Service Bulletin

Bulletin No.: PIC5736A

Subject: Inner Door Trim Panel Squeak Noise

Models: 2013 Cadillac ATS

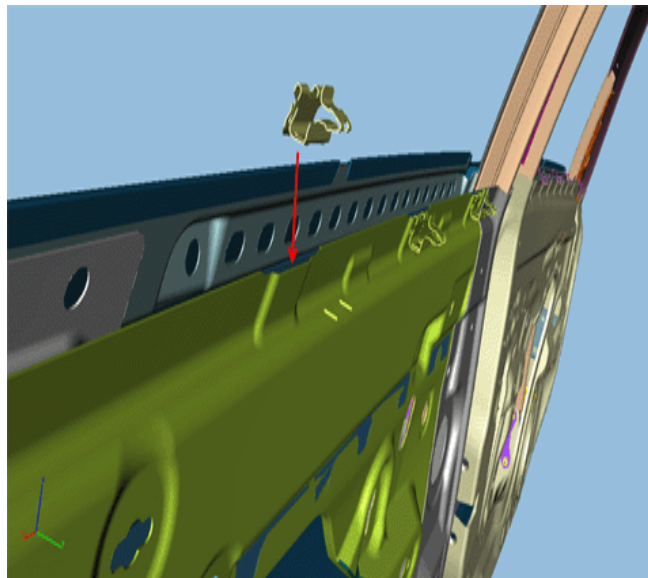
The interior door trim panel may exhibit a squeak or creak noise when pressing down on the top of the door trim panel (such as might occur when resting one's arm on the door trim). The noise is caused by non-coated door clips.

2911982

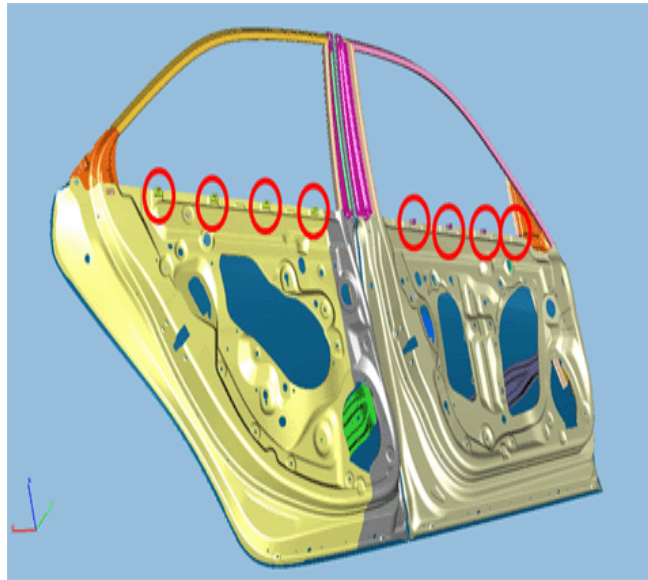
Note: There may be felt on the door and/or window inner sealing strip. The felt can be left in place for both locations.

2. Replace the clips (4 per door) with the dull finish clips provided through WPC.
3. Reinstall the interior door trim panel by referencing the appropriate Side Door Trim Replacement procedure in SI.
